Mr. James W. Smith, Jr.  
Coordinator of Mined Land Development  
Division of Oil, Gas, and Mining  
1588 West North Temple  
Salt Lake City, Utah 84116

Information regarding the as-built characteristics of the sedimentation pond No. 5 reconstruction was requested by the Division of Oil, Gas, and Mining in a letter addressed to Ben Grimes of Plateau Mining Company, dated April 22, 1981. Mr. Grimes has requested that I respond to said letter by providing the requested information. Therefore, outlined below are the requests from DOGM with the accompanying response.

Project Plateau Mining Co.  
Location Watts, Utah  
Station Sedimentation Pond No. 5  
Material Parent Material without Bentonite  
Sample No. \_\_\_\_\_

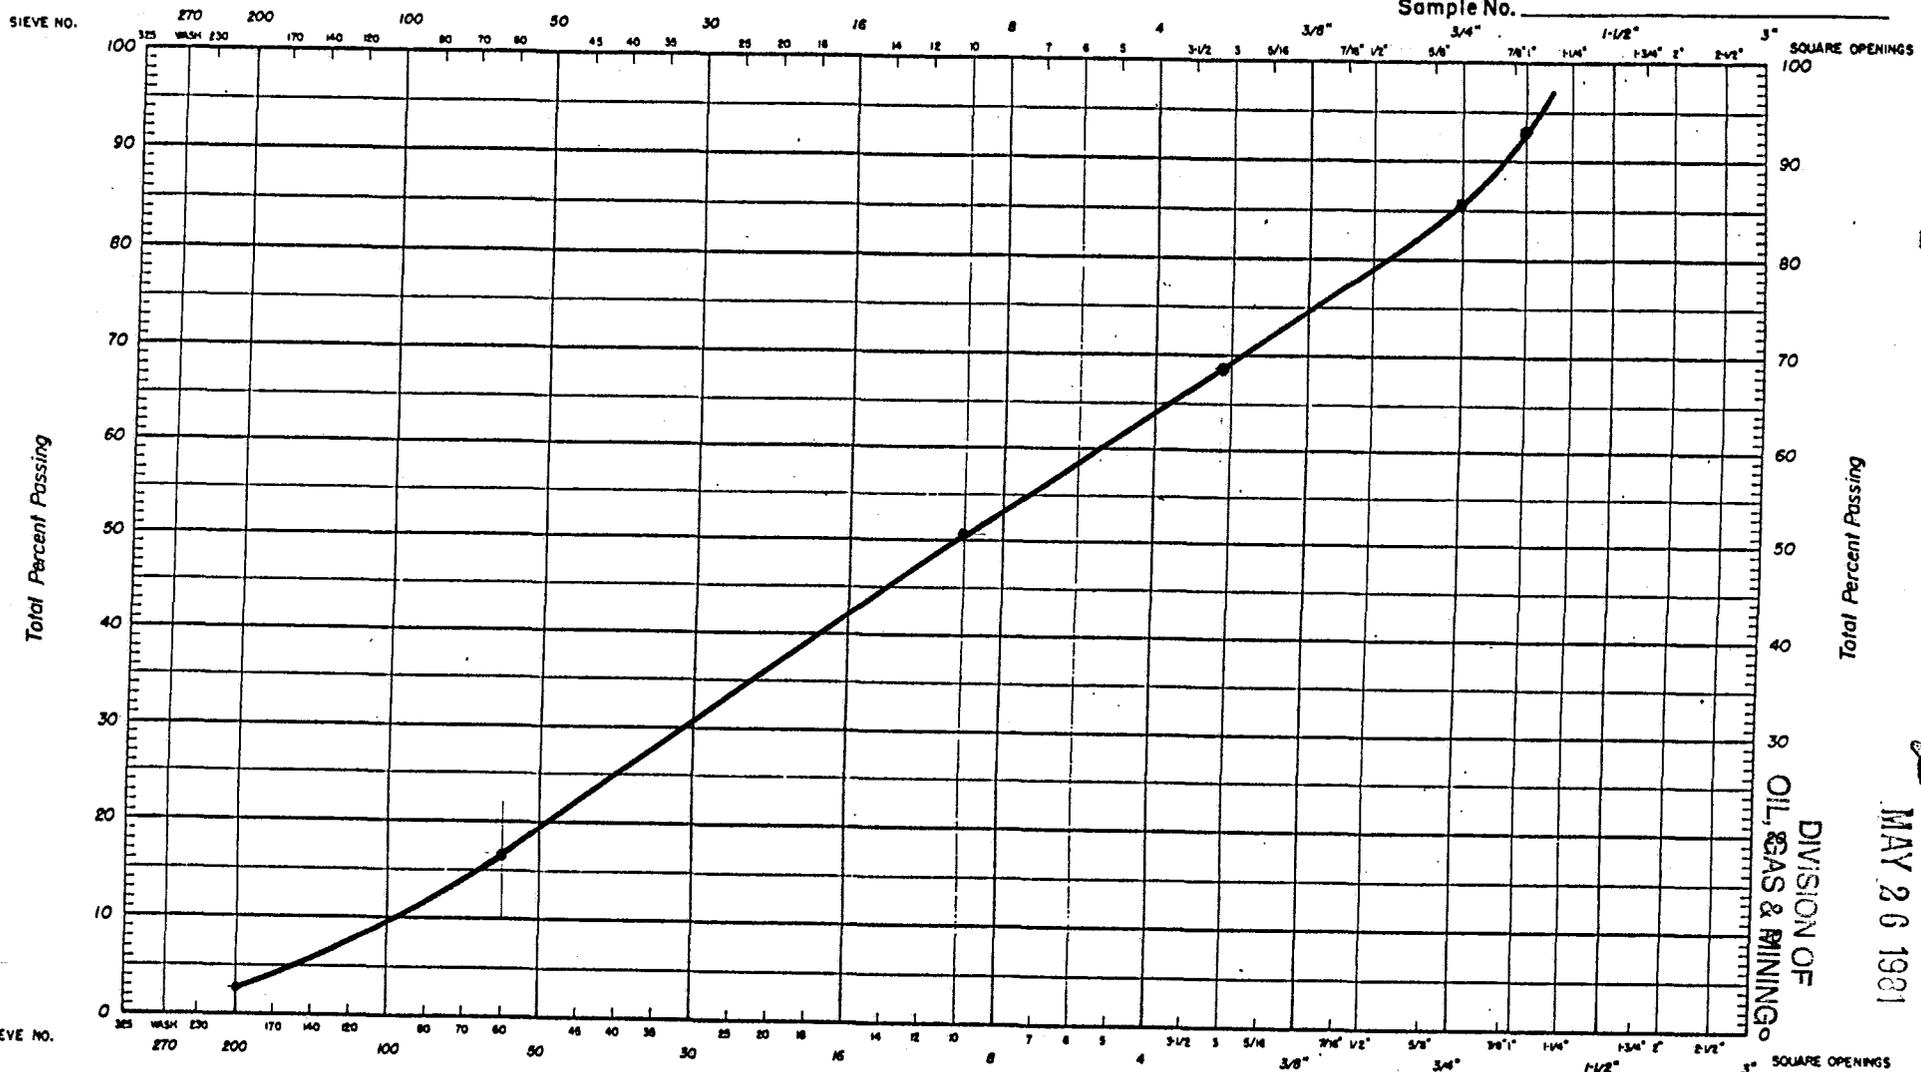
Request No. 1: Typical gradation curves for the clay core material and native material, along with Unified Soil Classification rating for these materials.

Response: The clay core material for the pond embankment was prepared by mixing bentonite with the parent material. The mixture ratio was approximately 20 percent bentonite to 80 percent parent material. A sieve analysis has been conducted on the parent material only. However, a typical gradation curve has been calculated based upon known properties of bentonite (i.e. particle size for bentonite clay is smaller than the standard openings in the No. 200 mesh sieve, and the dry unit weight is approximately 27 pounds per cubic foot). The typical gradation curve for the parent material is given in Attachment 1 and the typical calculated gradation curve for the bentonite-soil mixture is given in Attachment 2. The Unified Soil Classification rating for the parent material based on the conducted sieve analysis is SW, well-graded sands and gravelly sands with little or no fines. The Unified Soil Classification for the bentonite-soil mixture is a border classification between SP, poorly graded sands and gravelly sands with little fines, and SM or SC, silty sands or clayey sands. As illustrated in Attachments 1 and 2, the addition of bentonite to the native soil has increased the percent passing the number 60 sieve from 16.9 percent to approximately 21 percent and has increased the percent passing the number 200 sieve from 2.8 percent to approximately 8 percent.

In accordance with the Unified Soil Classification System, the permeability when compacted of a SW-SP soil is considered pervious, whereas an SM or SC soil is considered to be relatively impervious. Therefore, the addition of bentonite to the parent soil material, thereby resulting in the border classification of SP to SM or SC, should result in a semi-impervious embankment material.
